**UNITED STATES ENVIRONMENTAL PROTECTION AGENCY**  
**REGION 1**  
**5 Post Office Square, Suite 100**  
**Boston, MA 02109-3912**

**MEMORANDUM**

**Subject:** Improving Resolution and Technical Basis for CSM Relative to Main Street and Jewel Drive DAPL Pools, Olin Chemical Superfund Site (OCSS or Site), Wilmington, MA.

# Revised General CSM Model for DAPL Pool (e.g., Main Street DAPL area) Showing Measurement Uncertainties on DAPL surface and TOR Surface

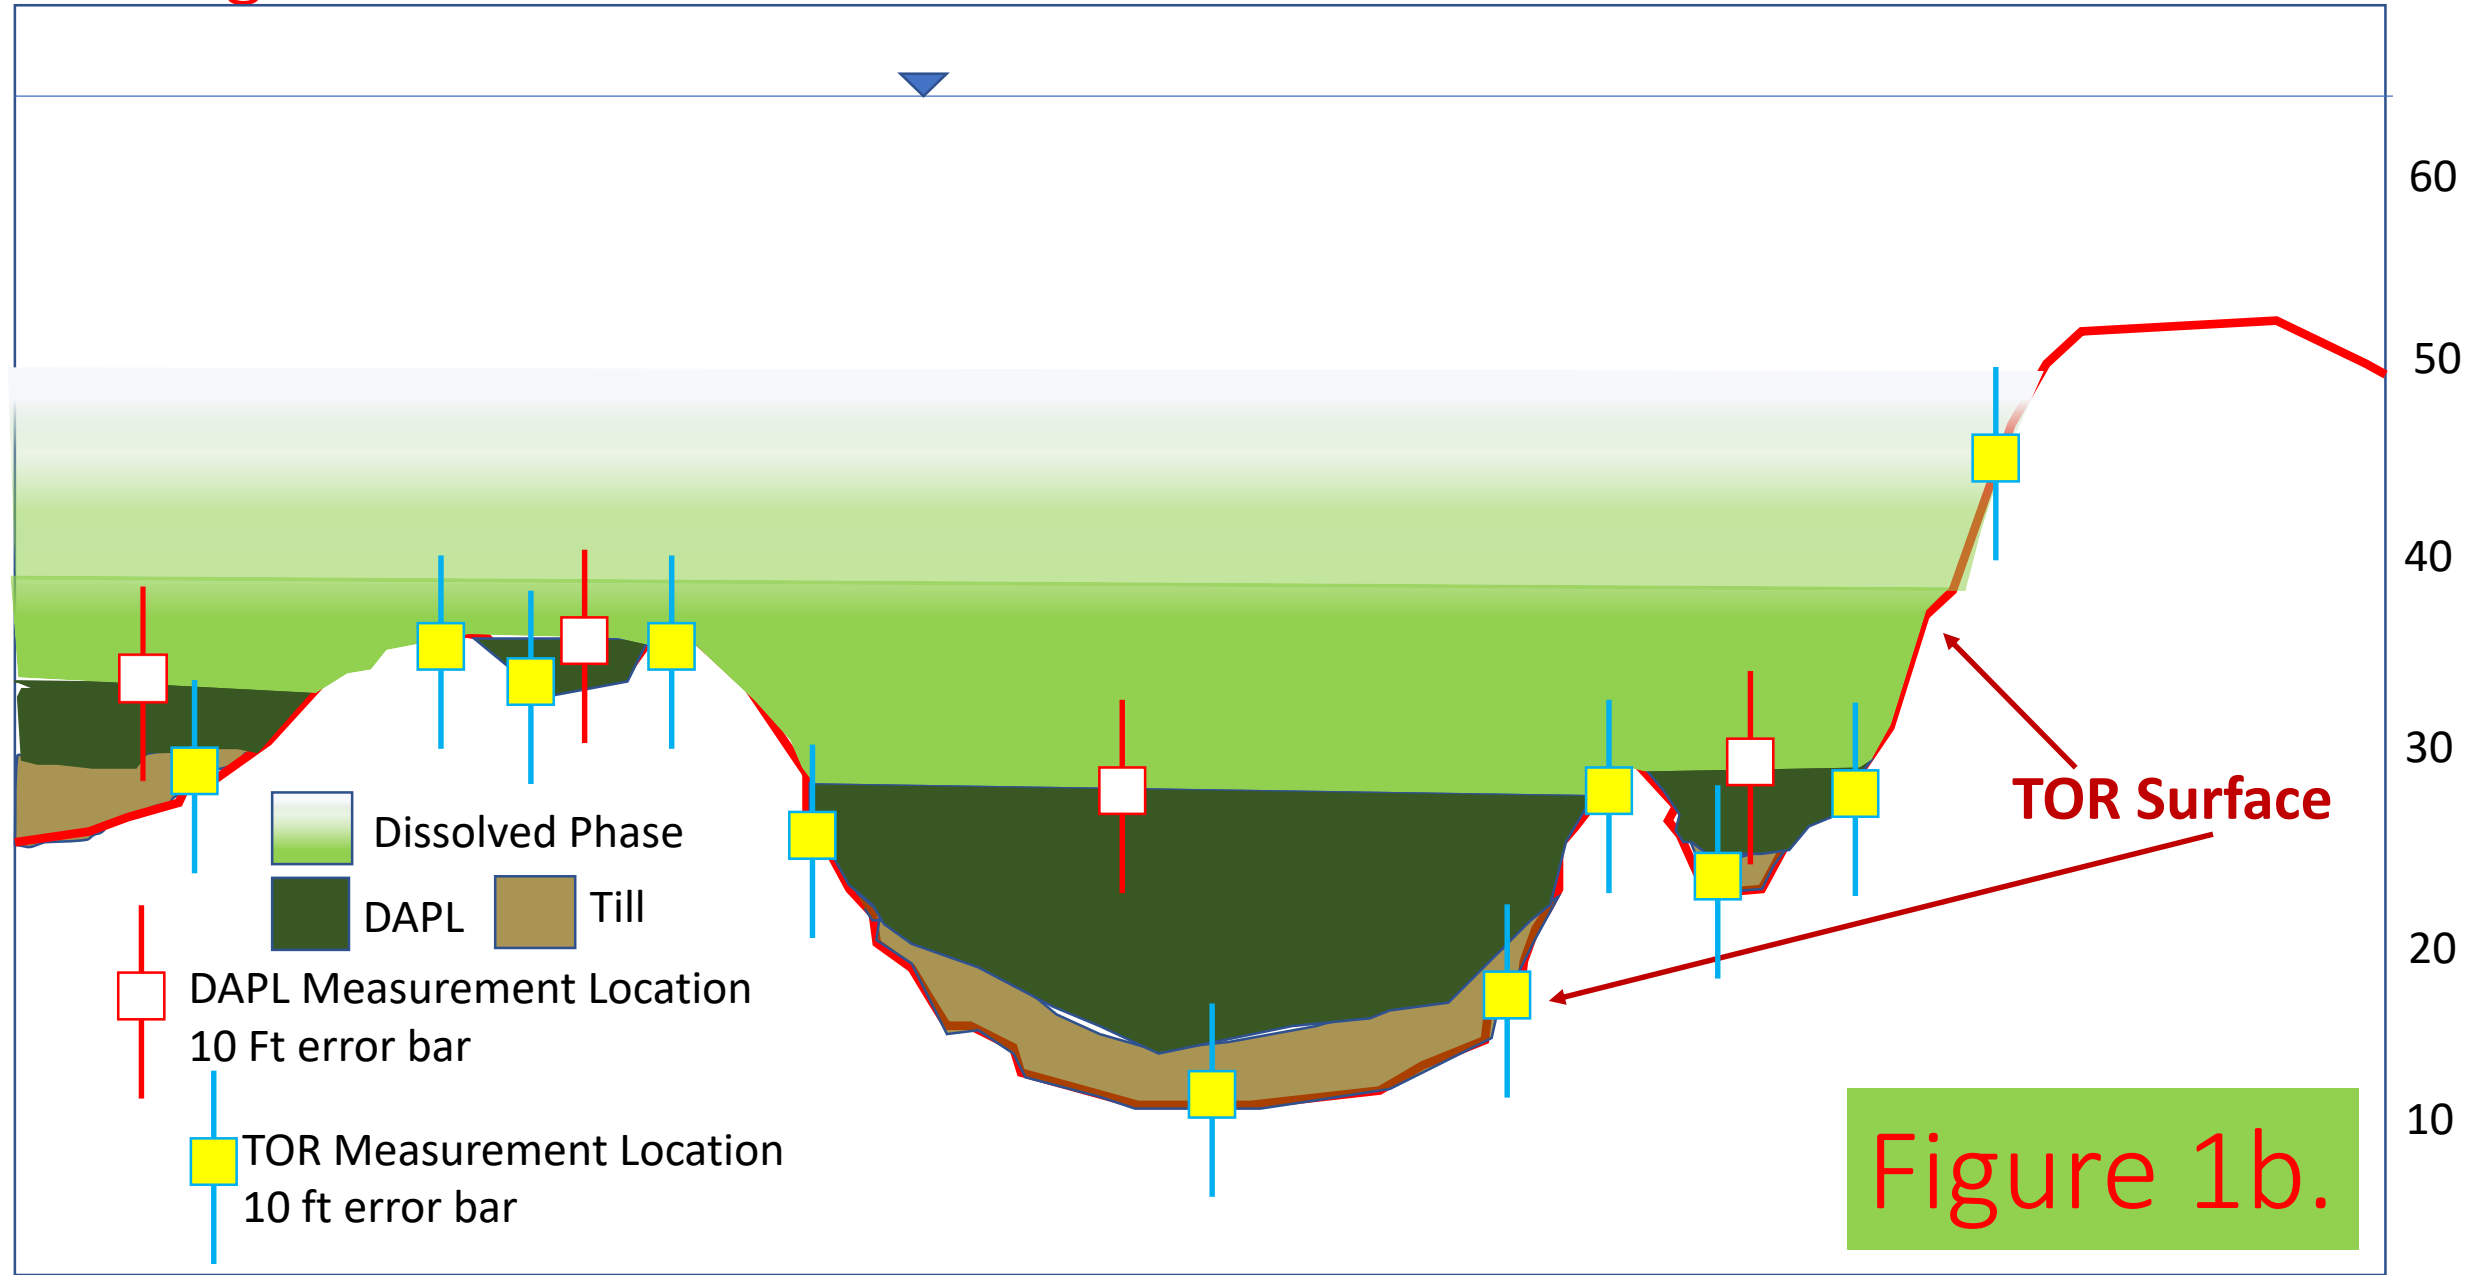
9. *DAPL measurement Error Bars, Issues, and Uncertainties:* EPA’s assessment concluded that the various approaches used to measure DAPL, although helpful for providing rough estimates of the volume, all have significant issues, error bars, and uncertainties associated with them. As such, they are not accurate enough to provide precise elevation depths and therefore, additional approaches will need to be employed in conjunction with follow-up efforts. As summarized above, these issues include the following:

Even with an understanding of these limitations, the currently available Site infrastructure and sparse DAPL monitoring network do not allow for unequivocal determination of DAPL position, elevation and thickness. In the Main Street area, only one multi-port well (MP-03) exists and that well is located in the corner of the Main Street DAPL pool and is not sufficient by itself to monitor/cover the larger area. There are also a few nearby monitoring wells. However, these wells have a minimum of 10-foot screen lengths, which also limits the accuracy of any measurements. Therefore, limited data are available to accurately evaluate the height, position and chemistry of this (Main Street) DAPL pool which covers an area several acres in size. More monitoring infrastructure is already in place at the Jewel Drive DAPL pool to support the ongoing DAPL extraction pilot test there. Two multi-port monitoring wells (ML-1 and ML-2) and two induction logging wells consisting of solid PVC filled with distilled water (ILW-1 and ILW-2) are located within 50 feet of the extraction well (EW-1). For well screen details, see Table 1 and Table 2 attached. For well configuration at the Jewel Drive DAPL pool, see attached Figure 2-1 from AMEC, 2014. This information has been used to develop a recommendation, below, to perform a limited scope investigation to clarify current DAPL mass configuration in that area as well as the comparability/accuracy of the various DAPL measurement methods (See Recommendations, below). Once completed, recommendations can then be made for implementing a robust DAPL monitoring program for other DAPL pools at the Site.

## Figure 2

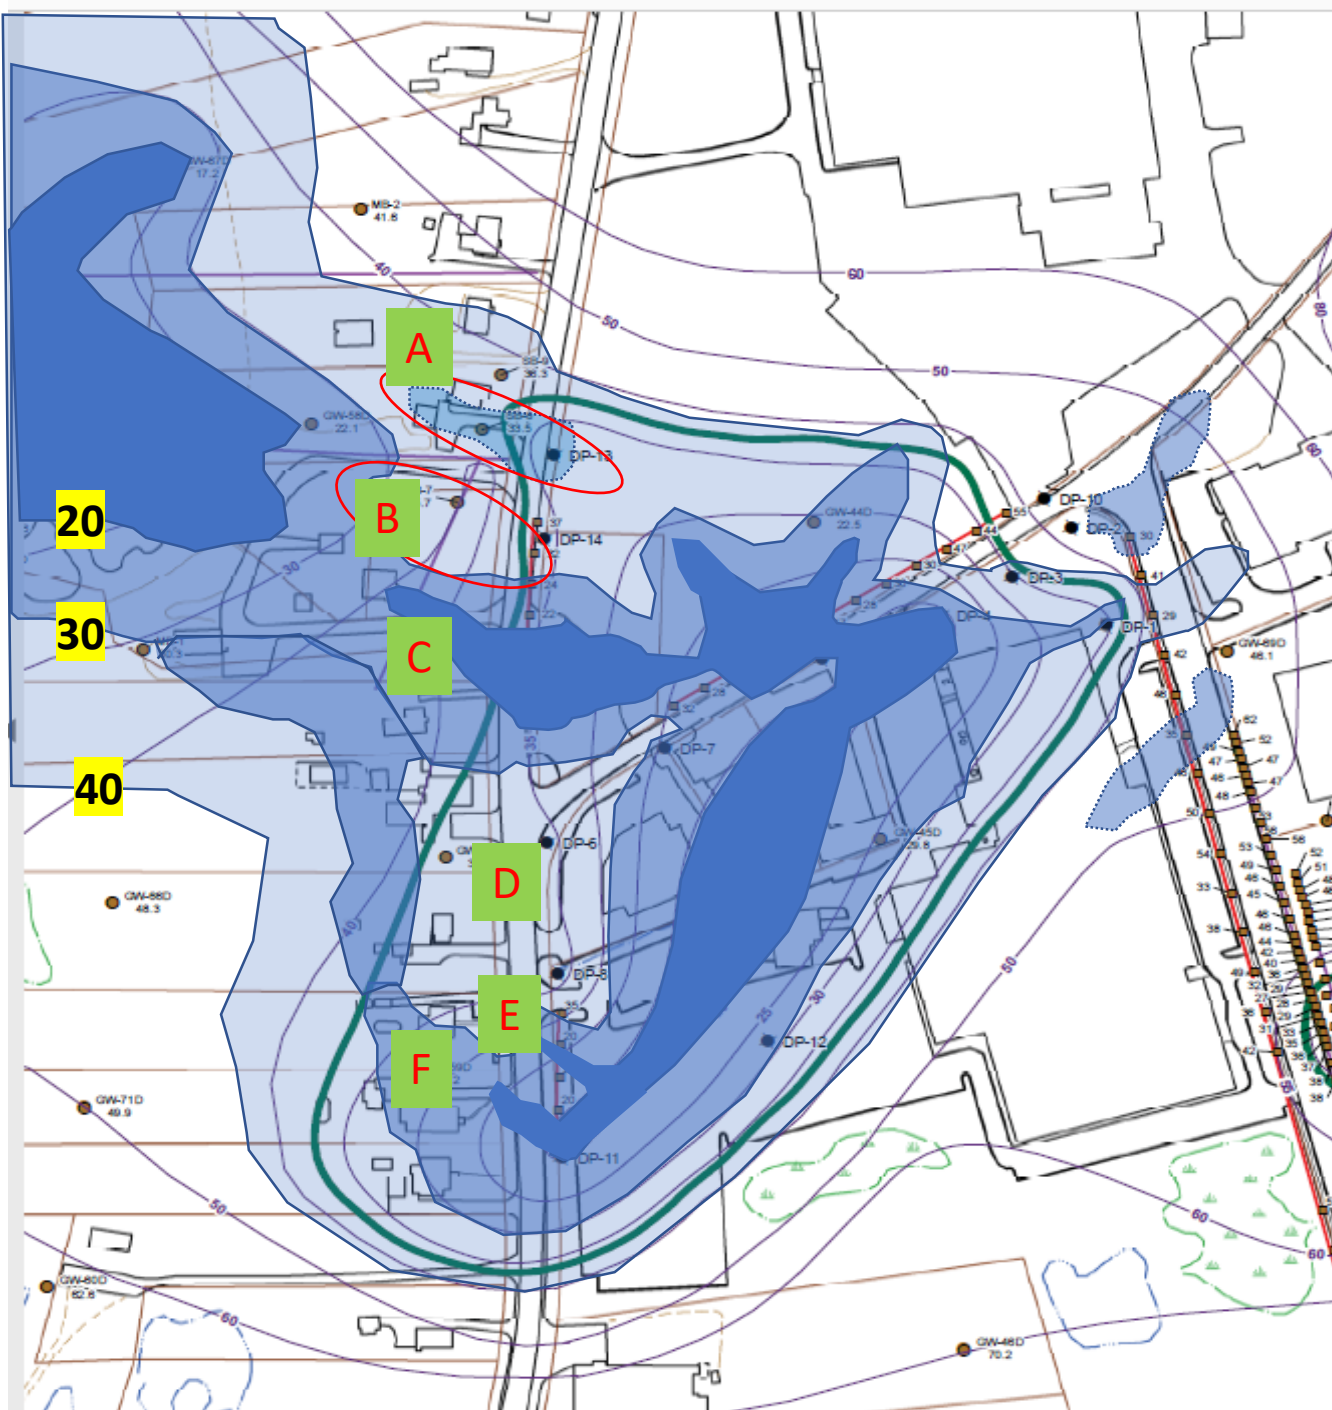
7. *Preliminary Assessment of Spatial Resolution of TOR surface at Main Street DAPL pool:* Given the TOR uncertainties for the various data types presented in the previous comment, a preliminary assessment of spatial resolution of the TOR surface beneath the Main Street DAPL pool is presented below. To complete this preliminary analysis, the area underlying the mapped outline of the Main Street DAPL pool, as shown on Figure 2.2-9 of the OU3 RI, was divided into two sections, north and south, as shown on the attached Figure 2. The borings, monitoring wells, direct push probe locations, and seismic stations shown on Figure 2.2-9 were totaled and used to prepare the following summary tables.

<b>BOX 1</b>						
<b>Data Type</b>	<b>Number of Points</b>	<b>Points per Acre</b>	<b>Acres per point</b>	<b>Lateral Spacing (min) feet</b>	<b>Lateral Spacing (max) feet</b>	<b>Comment</b>
Soil Boring	3	0.303	3.3	75	100	
Direct Push Boring	9	0.91	1.1	37	300	
Monitor Well	3*	0.303	3.3	638	825	
Seismic Reflection MP's	25	2.5	0.39	30	525	
Seismic Refraction Lines	375 LF					Not Included in Analysis due to questionable data quality
ALL PTS Total (excludes Refraction data)	40	4.04	0.25	0	300

<b>BOX 2</b>						
<b>Data Type</b>	<b>Number of Points</b>	<b>Points per Acre</b>	<b>Acres per point</b>	<b>Lateral Spacing (min) feet</b>	<b>Lateral Spacing (max) feet</b>	<b>Comment</b>
Direct Push Boring	4	0.63	1.575	150	500+	
Monitor Well	2	0.32	3.15	244	450+

Seismic Reflection MP's	5	0.79	1.26	30	>>300	No control in y-dimension
ALL PTS Total	11	1.7	0.57	30	500+

Basic conclusions from this analysis suggest that lateral resolution in the Main Street DAPL pool area - at best - are on the order of:

- One data point per quarter acre (northern portion)
- One data point per half acre (southern portion)

Combining this with the forgoing analysis of vertical resolution yields the following summary table regarding the spatial resolution on the TOR surface in the Main Street DAPL area:

- Lateral resolution: 0.25 to 0.5 acres (or greater)
- Vertical Resolution: < 1-foot (best case) to > 10-feet (worst case)

One must acknowledge that the Main Street DAPL area is a critical element of the Site CSM. One must also conclude that it is under-characterized for the purposes of demonstrating that the system as a whole, acts to control source migration. Additional resolution is needed. Even a cursory examination of this information inevitably leads to a conclusion that the Main Street DAPL area is woefully under-characterized, by just about any standard. Consider that a “typical” small UST site on the order of ¼ acre in size would typically require 3 to 4 monitoring wells, *at a minimum*. This would suggest an average lateral data density of 3 or 4 times that of the Main Street DAPL area. Even when considering the TOR surface as the only data objective, (which it is not), one would expect a much higher level of resolution on par with other significant source zones in bedrock, e.g., the Quarry and ES/JEBS sites at Loring AFB, Building 81 at NAS South Weymouth, etc. where data density is on the order of 50 to 100 points or more per acre in the high concentration source areas. If a remedy is selected for source control, additional effort will be needed to better understand the level of complexity of the TOR surface at the Main Street DAPL area, as a first order design data objective, to ultimately couple these data with more highly resolved assessments of DAPL occurrence, location, elevation and thickness to formulate a comprehensive and effective source control remedial action. See recommendations, below.

# FIGURE 3

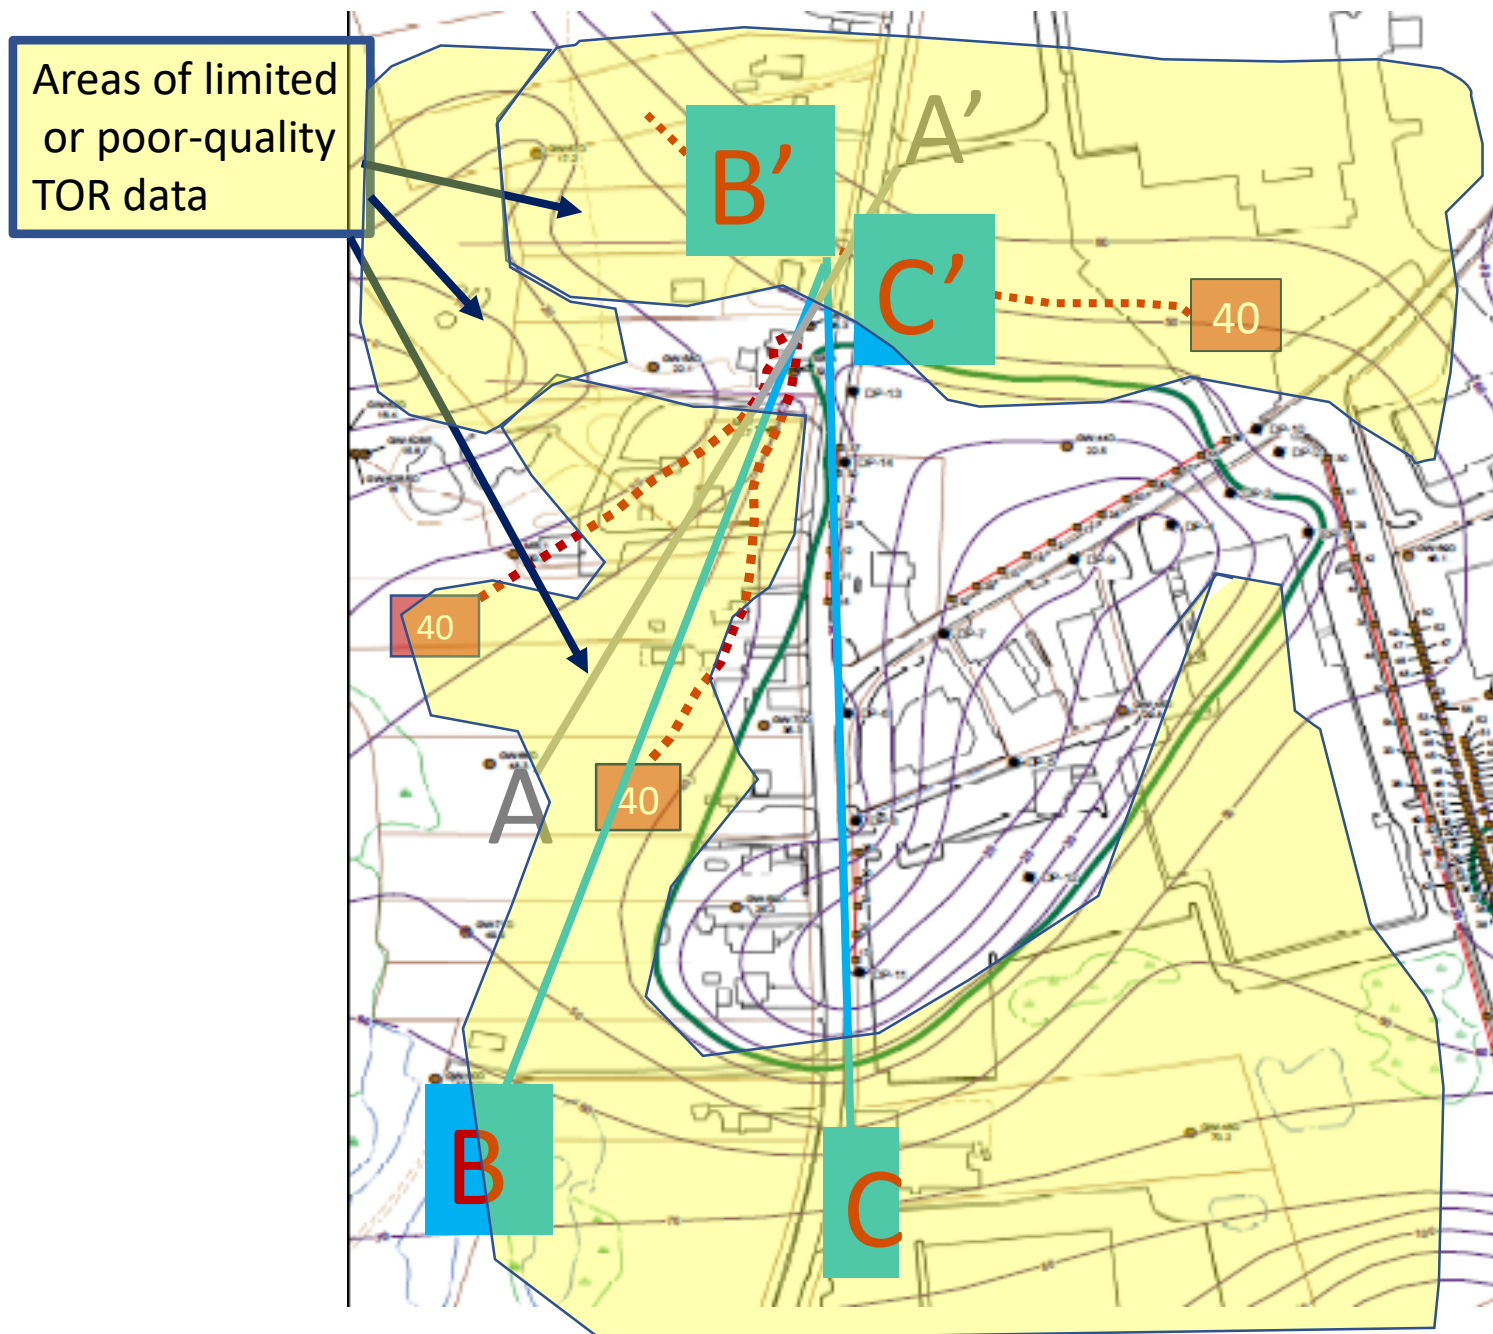
8. *Revised interpretation of TOR surface in Main Street DAPL:* A revised interpretation of TOR surface in the Main Street DAPL area showing features of interest and data gaps is included on the attached figures. Figure 3 is a map of the TOR surface in the Main Street area. Figure 4 is a cross section West of Main Street (B-B'), and Figure 5 is another north-south cross section aligned east of Main Street. It is interesting to note that the revised figures, which account for the error bars on the TOR data discussed in prior comments, allow room for an interpretation which identifies the Main Street “Saddle” as a smaller feature within a region of relatively higher bedrock elevations. This region is designated provisionally as the Main Street “Pinnacle”. As per this interpretation, there also appears to be a small disconnected depression on the bedrock surface in the general area of MP-3, which is designated provisionally as the Main street “Chalice”, which EPA interprets as an isolated depression of higher elevation than the average elevation of the Main Street DAPL pool. DAPL presence at this higher elevation may be due to its apparent morphology as a closed depression of

smaller scale, possessing an interpreted comparatively “tight bottom” - with a relatively sparse degree of fracturing - that only allows for limited excursion/migration of DAPL, at slow rates.

The resolution of this feature is weak given the limited data to the north and east. Additional seismic data proposed in Recommendation 3, below, will help to clarify the presence and dimensions of this feature. In the revised interpretation, the “spillway” feature previously identified by EPA has been moved slightly to the south to honor the seismic refraction data, but data quality issues have been identified with the refraction data, and a closer examination of that data does *not* support elimination of the “Spillway”. To the south of the “Spillway”, an additional area of relatively higher elevation bedrock, provisionally designated the “Plateau” has been identified. South of the “Plateau”, a smaller scale depression/trough designated as the “Southern Slot” has been identified and is located within a larger-scale depression herein designated as the “South Drainageway” feature. The potential importance of these low-lying valley-like features strongly suggests the need for further resolution in this southern part of the greater Main Street DAPL area. Further data collection is proposed below (See Recommendations), to allow for improved resolution on the TOR surface in the Main Street DAPL area to confirm the presence, dimensions and elevations of these features as well as to refine the CSM to appropriately inform remedial efforts. Please see associated figures, attached. Again, the presence of these features further supports the need for evaluating source control actions that minimize the migration of both DAPL and highly contaminated groundwater. If a remedy is selected for source control, the recommended data collection efforts will be needed to support the design of effective source control remedial measures.

- Revisit previous conclusions by applying revised/alternative modern methods where appropriate/necessary.
2. *Main Street DAPL area:* As discussed in GC 8, above, additional data is needed to more accurately resolve the TOR surface in the Main Street DAPL area. Given the quality of the previous seismic reflection data, this method should be augmented to produce a focused “grid” of seismic reflection data which can be used to produce an updated and improved 3-D map of the TOR surface by employing a methodology which provides a level of vertical resolution of 5 feet or less and lateral resolution of 50 feet or less in all directions. Seismic reflection data should be collected using a relatively fine grid spacing, with a similar or closer geophone spacing as previous seismic reflection surveys (30 feet or less). A 50-foot grid-spacing between lines is proposed for the seismic reflection surveys as a starting point for discussions. However, it may be possible to reduce the density of coverage after discussions with geophysical contractors. A soil boring program, including confirmatory rock cores (e.g., 5 feet or greater), should be employed at least 10 percent of the seismic stations, including at all key locations, to confirm seismic-determined TOR depths. The attached Figure 6 shows the proposed area of supplemental coverage for discussion purposes, which is focused to the western margin of the Main Street DAPL pool, including the previously discussed “Saddle” and “Spillway” features as well as the newly-designated “Chalice”, “Pinnacle”, “Plateau”, “Southern Slot” and “South Drainageway” features.
